January 21, 2022

File No. 20199

**Re: Skydevco
Municipality of Meaford - Responses to Second Submission ZBA Comments
Zoning By-law Amendment (Z04-21)
Fuller Street and Boucher Street East Redevelopment**

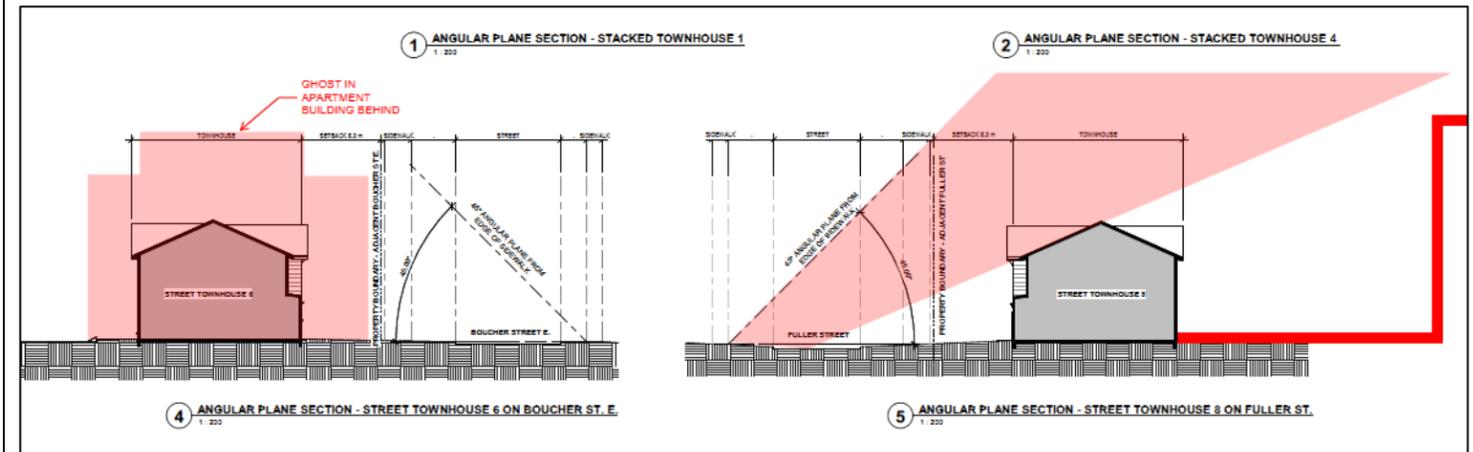
- a) *The lands will be planned and redeveloped in their entirety as opposed to being developed in an ad-hoc or piecemeal basis.*
- b) *The lands will be used for a suitable mix of residential, open space and commercial uses related primarily to the hospitality, tourism and service sectors.*
- c) *The development will be compatible with surrounding residential uses.*
- d) *The development will create and improve linkages to existing open space and harbour lands and will maintain public access to the waterfront.*
- e) *The development will provide pedestrian space and access to the waterfront and will minimize the amount of space use for parking cars.*
- f) *The development will support the objectives of the Urban Area Waterfront designation and the Waterfront Strategy and Master Plan, as may be amended from time to time.*

c) The Proposed Development organizes buildings to transition appropriately and be compatible with the surrounding residential uses. The two-storey street townhouse units face both Fuller and Boucher Streets, opposite single-detached houses. The proposed street townhouses are a similar scale to these residential buildings in scale and height, providing a compatible transition between the existing and proposed dwellings. The apartment building has been reoriented along Boucher Street East, further away from existing residential uses. This placement is considerate of and mitigates the impact on existing residential uses in the area. A 45 degree angular plane is a widely accepted urban design principle that achieves a comfort level for pedestrians in seeing sky views, and demonstrated in the Angular Plane figure, is well within this accepted standard.

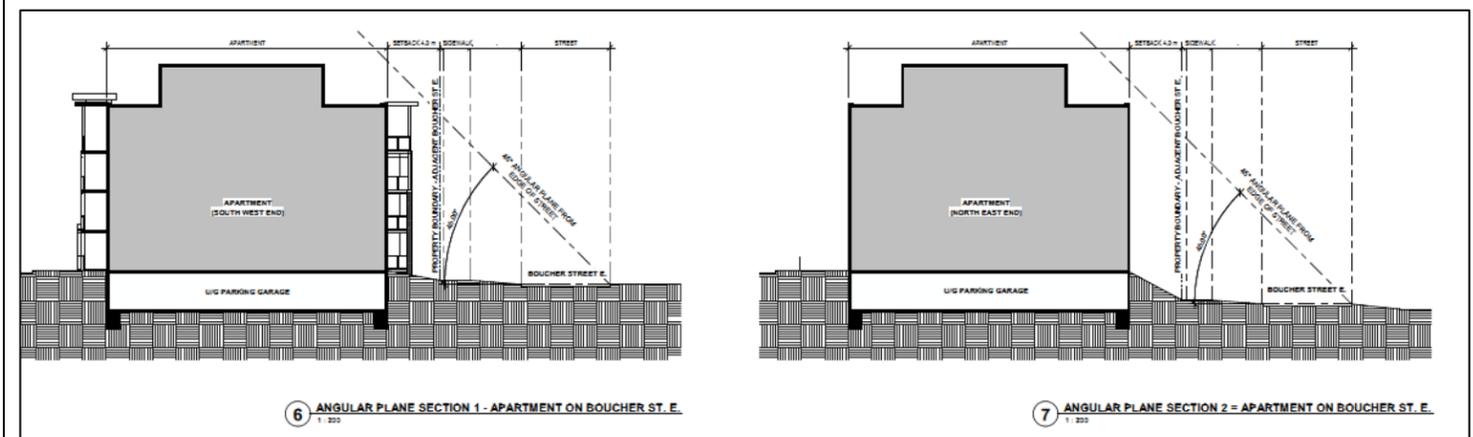
- the streetscape design conditions created with the residential units along the perimeter streets and how they are fitting in terms of building mass, streetscape landscape design, sidewalks/walkways;

Response: The massing of the existing residential dwellings opposite the site on Fuller are single-detached houses. The two-storey street townhouse dwellings proposed on this site are located facing the existing houses on Fuller and Boucher, providing a similarly scaled built form transition to the Site. Sidewalks and streetscape design including landscaping along Fuller and Boucher Streets will meet Meaford standards for full urban cross-sections providing broad concrete walks, streetlights and street trees within boulevards in addition to on-site. The below cross-section graphics demonstrate what a pedestrian would see walking along the east side of improved Boucher Street and the south side of Fuller Street looking towards the street-fronting townhouses and apartment building.

A 45 degree angular plane is a widely accepted urban design principle used to establish maximum building heights. The principle establishes a "comfort level" for pedestrians walking along the opposite side of a street, wherein they will be able to see open skyviews above a building. Graphic 1 shows that both the street-fronting townhouses and, more importantly, the apartment building will be well below a 45 degree angular plane, providing skyviews above both buildings.

Graphic 2 also confirms that pedestrians walking along the south side of Fuller Street will only be able to see the street-fronting townhouses, whereby the apartment building (depicted by the heavy red line) would be below the viewshed.
